# Facility: Twin Lakes Recreation Area

Address: 2500 Chapel Hill Road      Date of Survey: 06/04/10

Photo 4

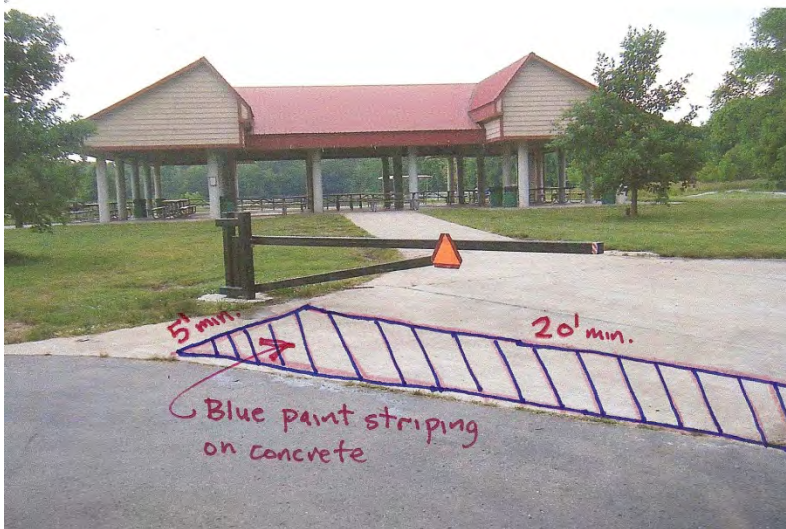
- Refer to site plan included with this report: (5) Due to lack of wheelchair accessible path from the ADA parking spaces in the lower NW parking lot, it is recommended that an accessible drop-off area be added at the large concrete area adjacent to the road near the shelter (see photo 4 below). Stripe (blue paint) a min. 5' wide x 20' long access aisle for the new passenger loading zone to be used for drop-off and pick-up of persons with disabilities who are using the shelter, accessible restrooms, playground or accessible fishing dock. Add an ADA passenger loading zone sign to demark this area.
